Rhydycar West, Merthyr Tydfil

Access Roundabout Design Audit

784-B023905

APPENDIX A: DRAWING 784-B023905-TTE-00-ZZ-DR-CH-SK001-P03

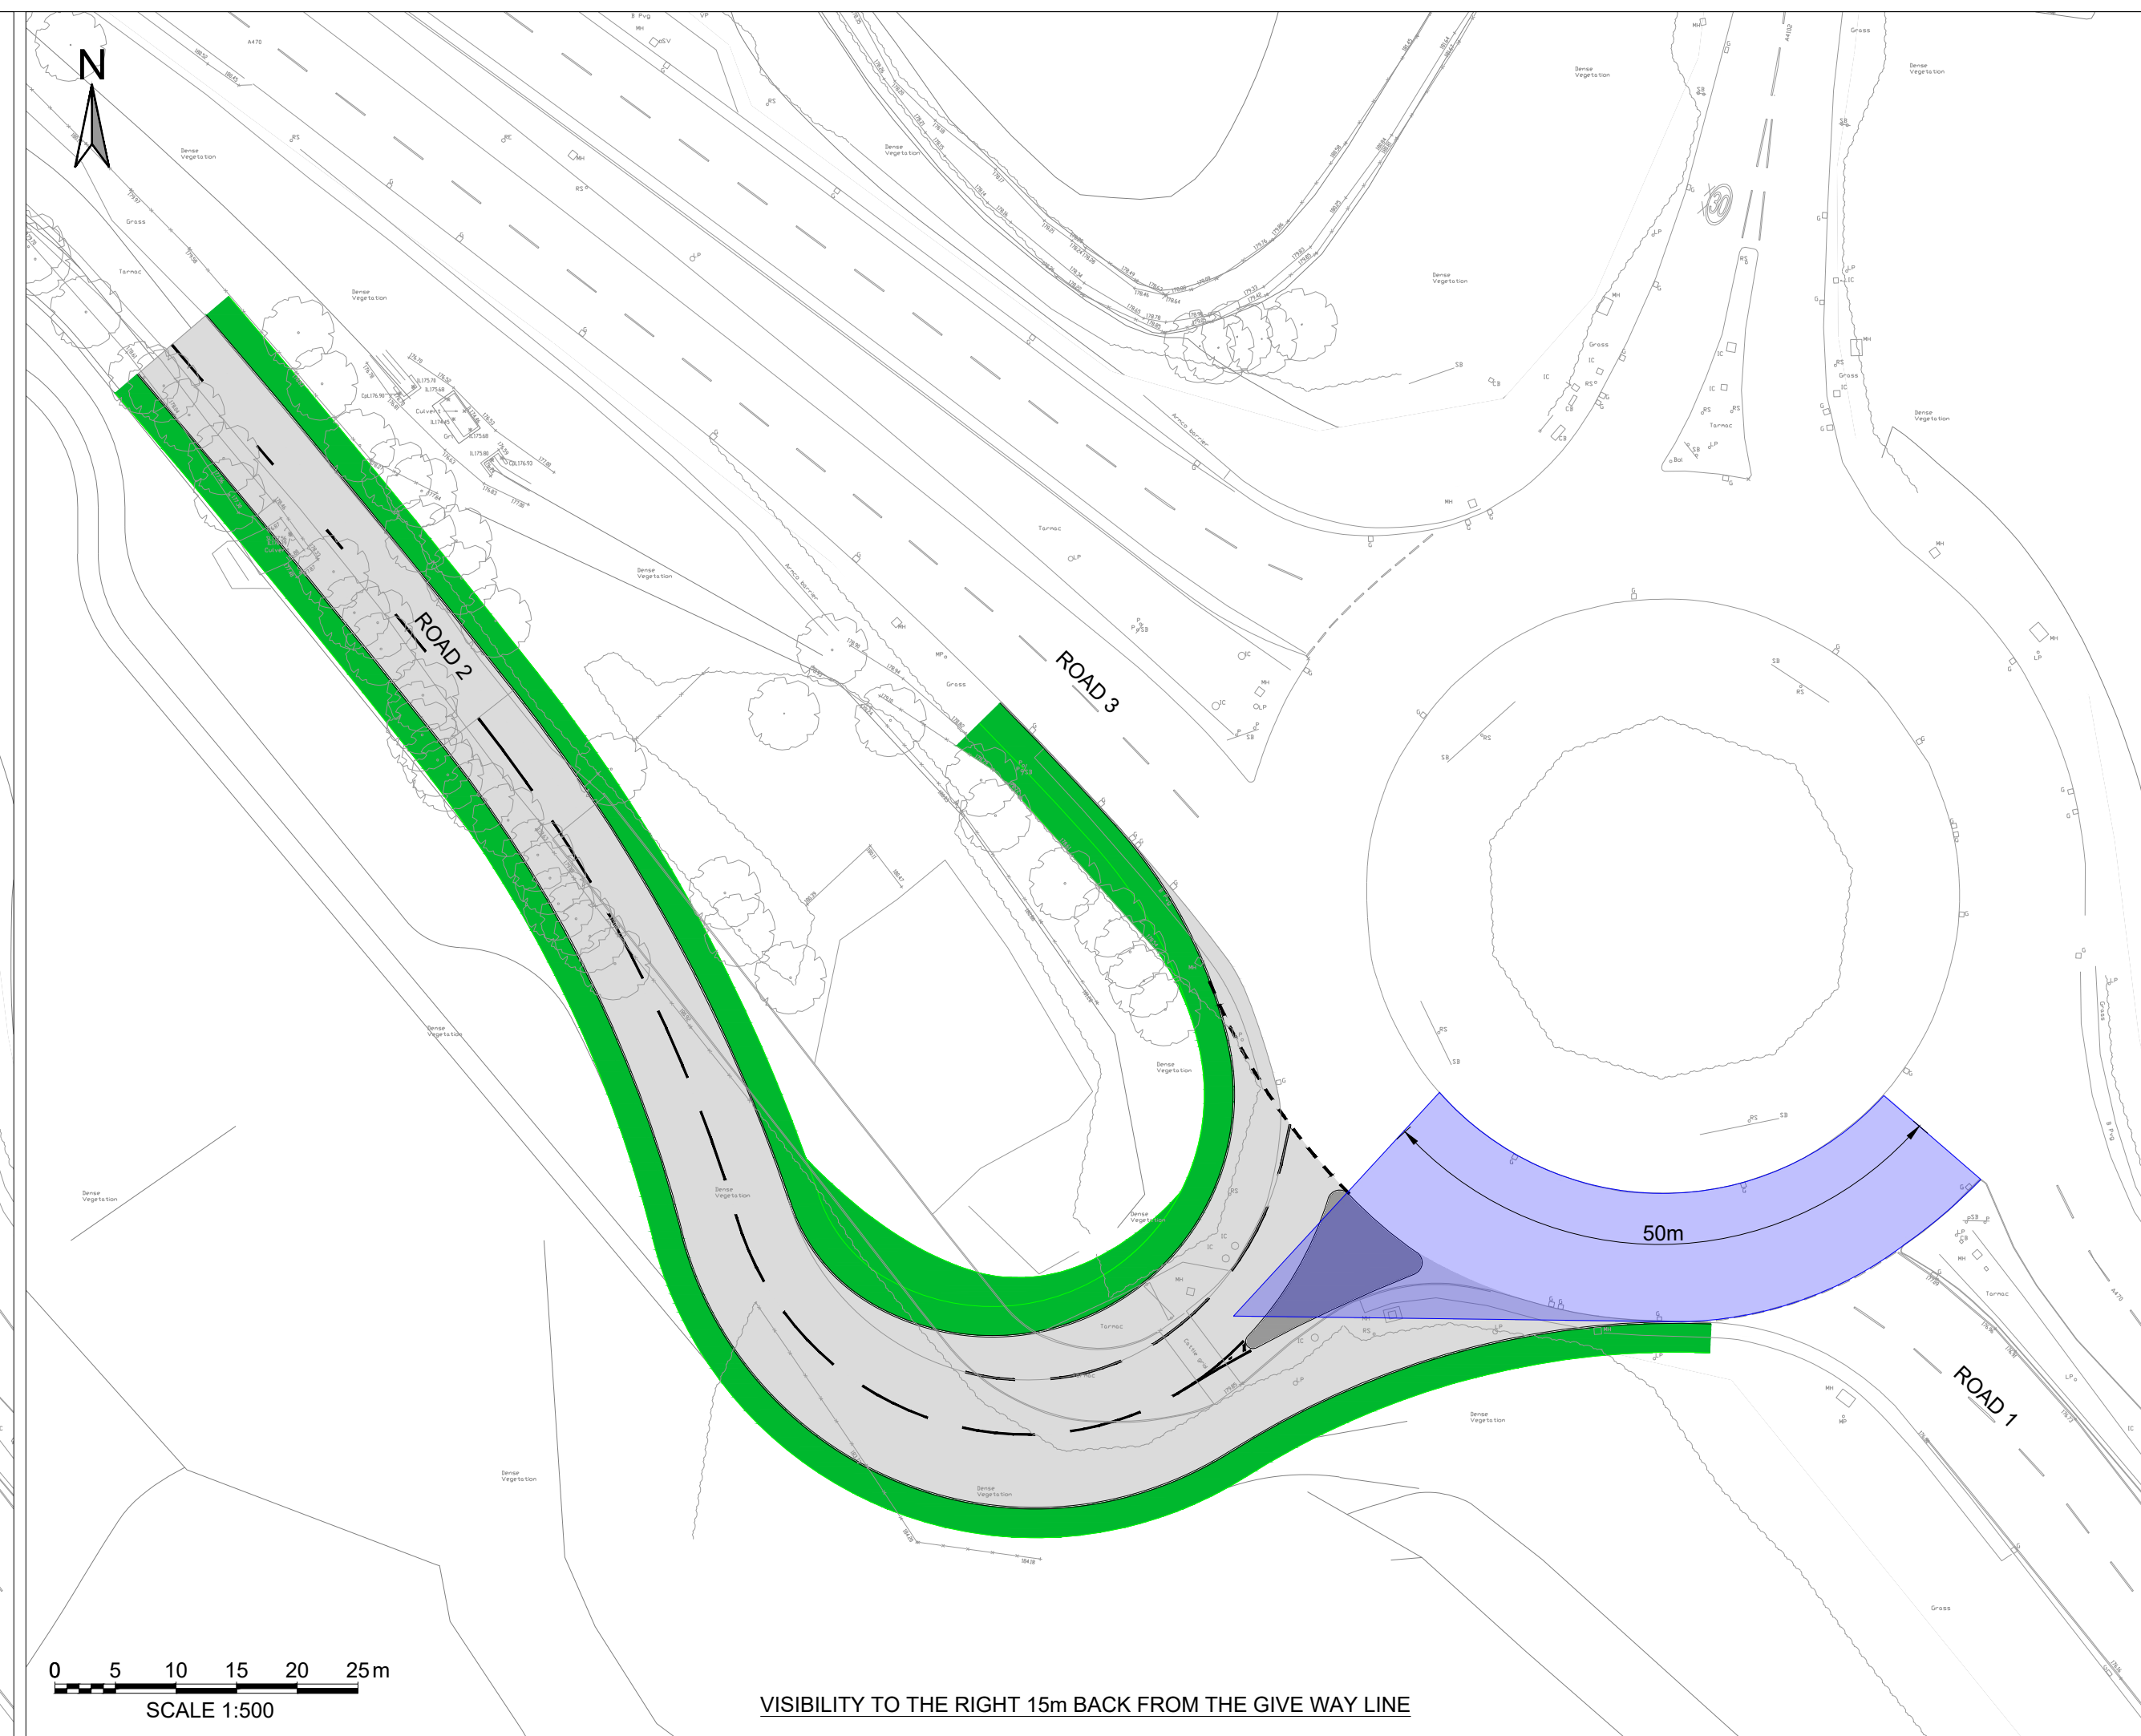
- 30 Forest Lodges (up to 2,000 sqm).
- 1.3 Welsh Government's Transport Network Management Division provide a response to the highways materials submitted under Planning Application P/23/0065, citing that the developer should ensure that the junction improvement **Drawing 784-B023905-TTE-00-ZZ-DR-CH-SK001-P03** dated October 2021 is compliant with trunk road standards (DMRB), in particular CD116.

- 1.4 This report forms a Design Audit, prepared to provide confidence that the proposed works as illustrated in **Drawing 784-B023905-TTE-00-ZZ-DR-CH-SK001-P03** are compliant with the DMRB. The drawing is provided at **Appendix A**.

PROPOSED ACCESS
GEOMETRY AND VISIBILITY

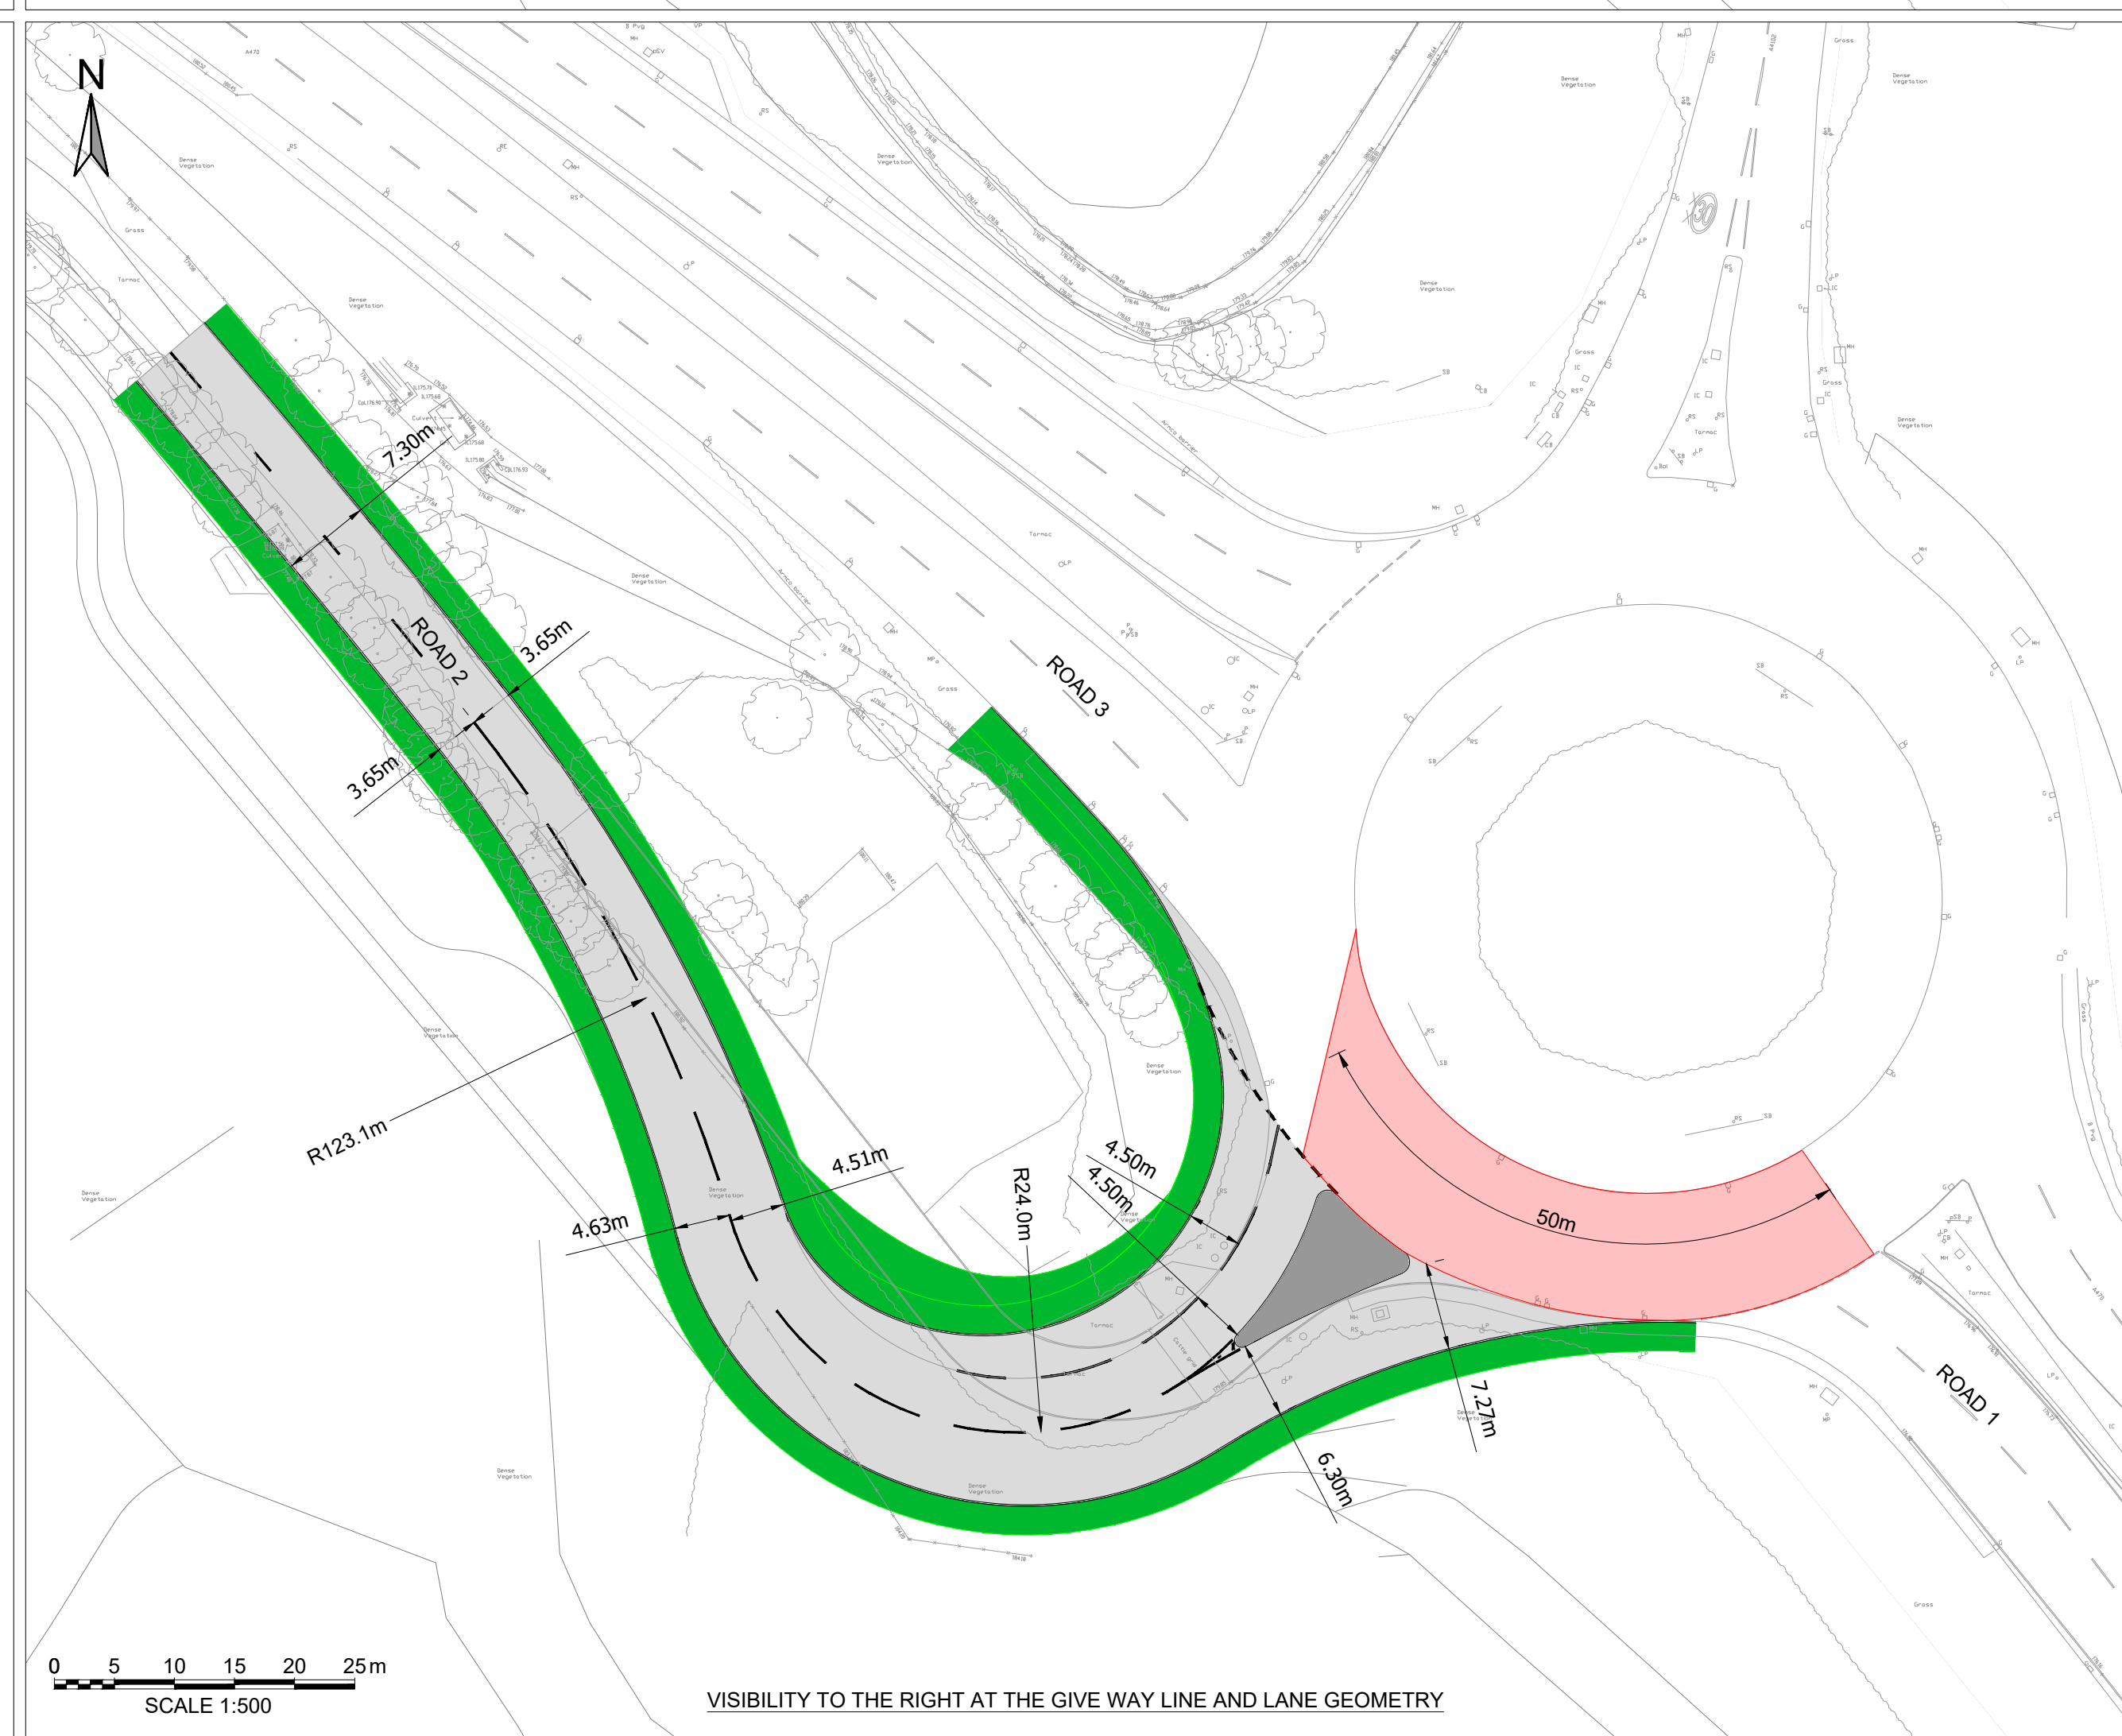
- 3.1 The geometric criteria and visibility splays for the proposed site access are detailed on **Drawing 784-B023905-TTE-00-ZZ-DR-CH-SK006**, provided at **Appendix B**.

- 3.4 The entry width is 9.00m, consisting of two lanes, and is compliant with DMRB CD116 Cl. 3.11 and Cl. 3.12.
- 3.5 The lane widths at the give way line are 4.50m and are compliant with DMRB CD116 Cl. 3.14. Although DMRB CD116 Cl. 3.14.2 suggests that lane widths for multilane entries should be between 3.00m and 3.50m, DMRB CD116 Cl. 3.14.4 states that vehicle swept paths should be assessed on multi-lane entries to ensure that sufficient width is provided for each entry lane. The provision of 4.50m entry lanes accommodates the swept paths of the large coaches anticipated to use the proposed access and is therefore considered to comply with the entry width requirements contained in CD116.

- 3.6 The average effective flare length is 34.78m and is compliant with DMRB CD116 Cl. 3.17 and Cl. 3.17.1. The flare length is dictated by the swept paths of the large coaches that will use the proposed access.

- 3.7 The entry angle is 24.02° and is compliant with DMRB CD116 Cl. 3.18 and Cl. 3.18.1.
- 3.8 The entry radius is 20.00m and is compliant with DMRB CD116 Cl. 3.19, Cl. 3.19.1, 3.19.2 and Cl. 3.19.3.

- 3.9 The entry path radius (deflection) is 24.40m and is compliant with DMRB CD116 Cl. 3.20 and Cl. 3.36.
- 3.10 The exit width is 7.27m reducing to 6.30m at the end of the splitter island and is compliant with DMRB CD116 Cl. 3.28 and Cl. 3.28.2.

- 3.11 The exit taper has not been assessed, as the curve widening required on the downstream link supersedes the exit taper criteria.
- 3.12 The exit radius is 68.80m and is compliant with DMRB CD116 Cl. 3.29, Cl. 3.29.3, and Cl. 3.6.8.

- 3.13 A Stopping Sight Distance (SSD) of 43m has been provided on the site access in accordance with MfS and MfS2.
- 3.14 Visibility on the approach to the give way line has been assessed in accordance with CD116 Figure 3.45. SSD of 43m, appropriate for a design speed of 30mph in accordance with MfS and MfS2, is provided.

- 3.15 Visibility at entry has been assessed in accordance with CD116 Figure 3.49N. Visibility of 50m around the circulatory carriageway, appropriate for a roundabout Inscribed Circle Diameter (ICD) of 70m, is provided. It is noted that an existing traffic sign within the central island encroaches on the visibility at entry and it is assumed that this will be relocated during the detailed design stage.

- 3.16 Visibility to the right measured at the give way line has been assessed in accordance with CD116 Figure 3.51. Visibility of 50m around the circulatory carriageway, appropriate for a roundabout ICD of 70m, is provided.

- 3.17 Visibility to the right measured at 15m in advance of the give way line has been assessed in accordance with CD116 Figure 3.52. Visibility of 50m around the circulatory carriageway, appropriate for a roundabout ICD of 70m, is provided.
- 3.18 **Table 1** provides a summary of the design illustrated at **Drawing 784-B023905-TTE-00-ZZ-DR-CH-SK006**, which is the site access proposal for this application.
